CERTIFICATE OF APPROPRIATENESS PLACARD

410 Glenwood Ave

COA-0148-2025

Material and Detail Modifications to Previously-Approved COA

Comparative Views of Parking Garage Mesh

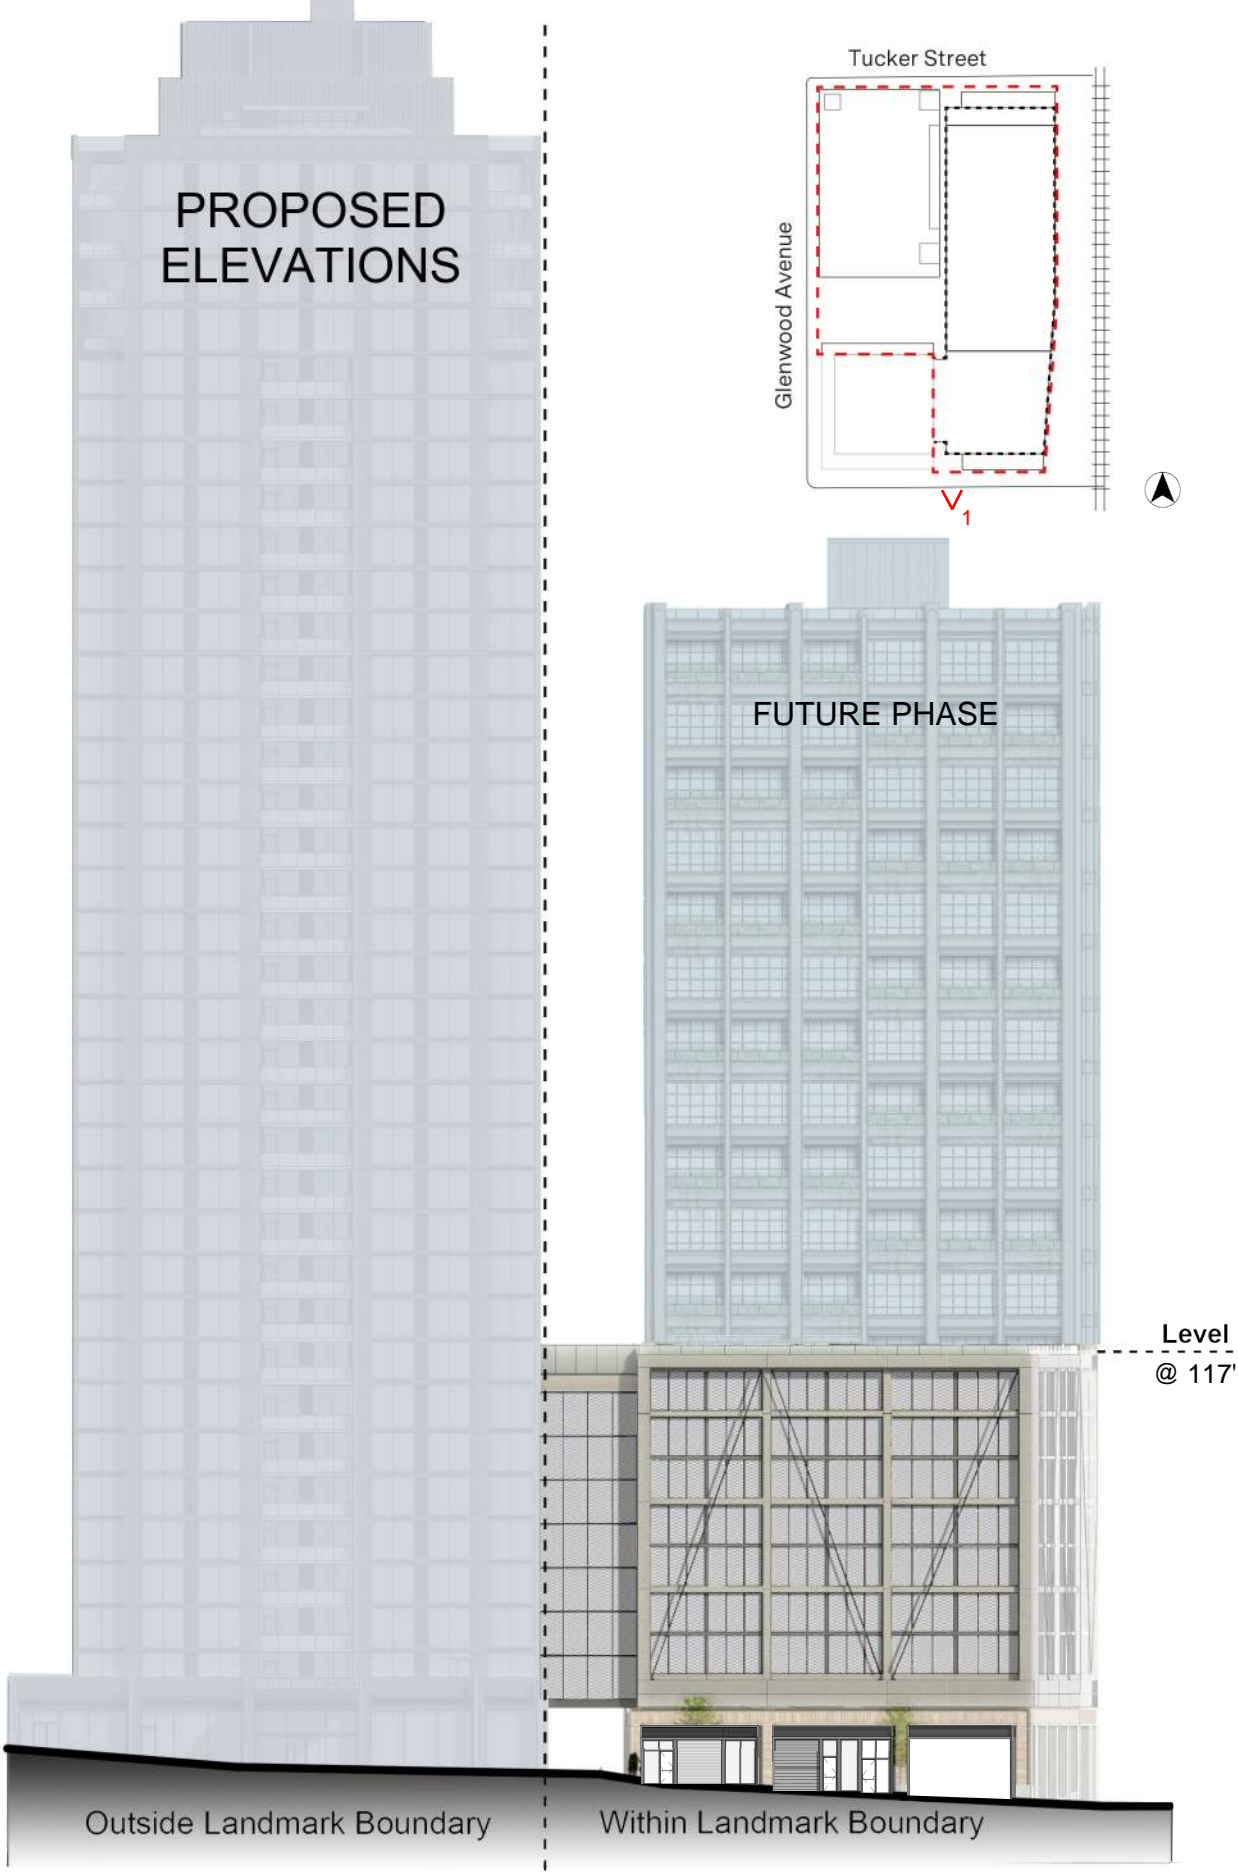
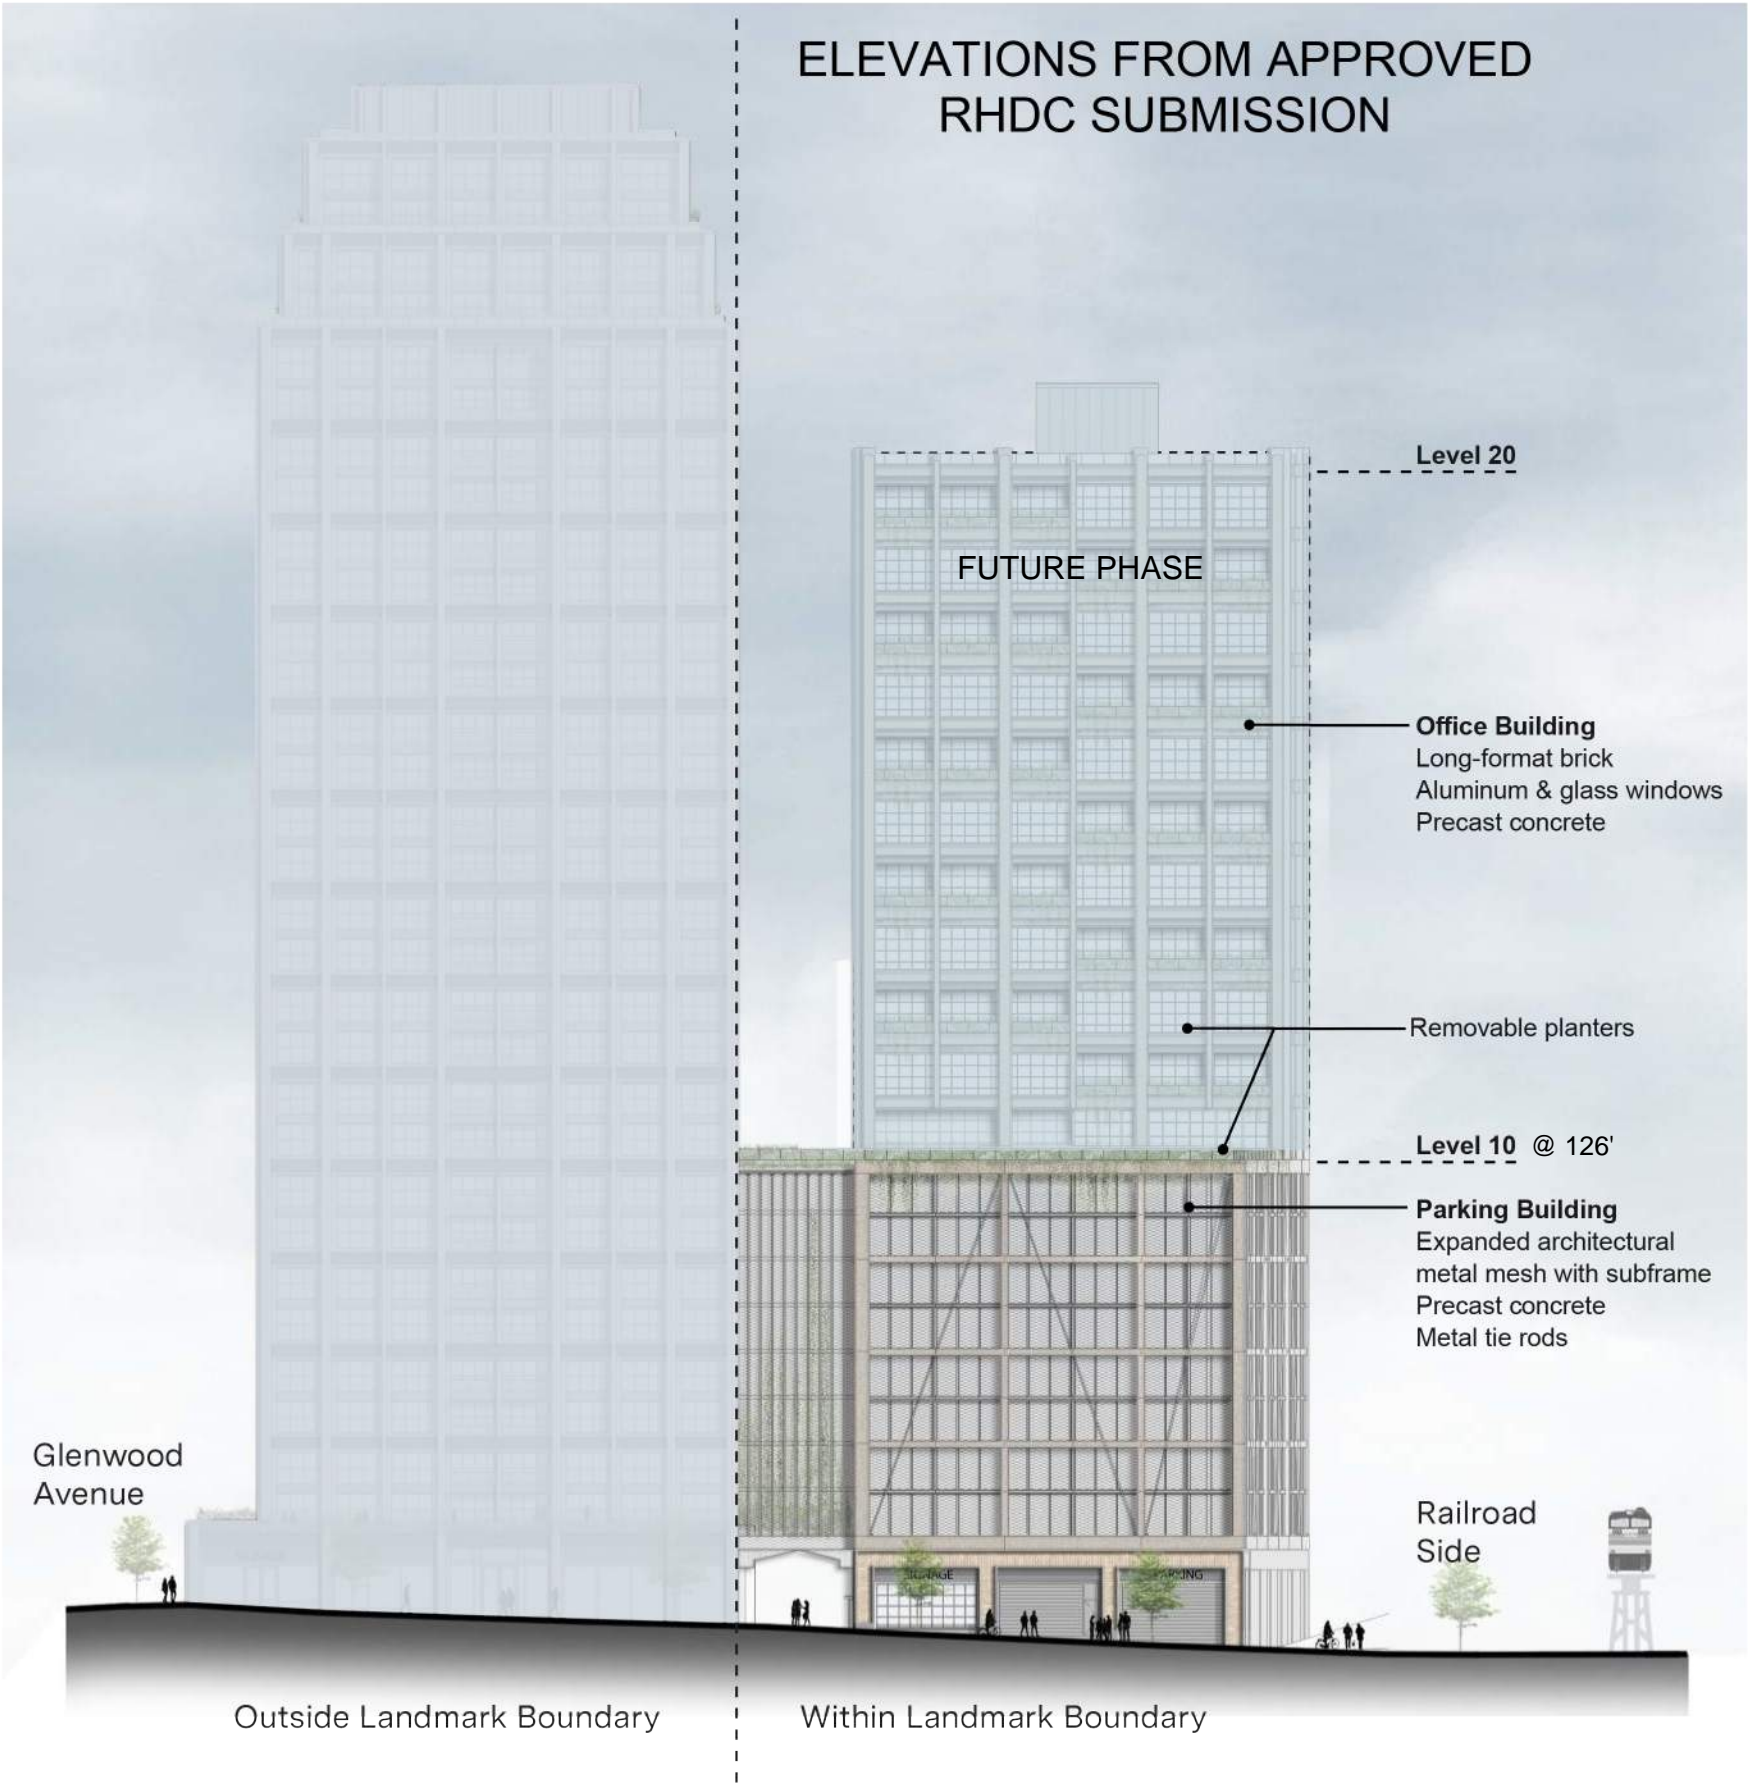
1. The industrial grid has been revised from precast concrete to painted metal panel. As shown in the comparative elevations for the previously-approved and currently proposed elevations, the overall massing, dimensions, and color range of the industrial grid will be generally consistent with the previously-approved COA:
 - The rectangular profiles and widths of the grids (3'-0" for primary and 1'-6" for secondary) match the previously-approved design.
 - Due to manufacturing limitations, the proposed depth of the frame decreases from 12" to 10".
 - The 3" diameter tie rod is visually consistent with the previously-approved COA.
2. The mesh screening has been revised from expanded metal to perforated corrugated metal:
 - The level of transparency is generally consistent with the previously-approved COA.
 - The color is consistent with the previously-approved COA.

2. Side-by-side photos of the previously-approved renderings and local installations of the proposed mesh illustrate comparative day and night conditions.
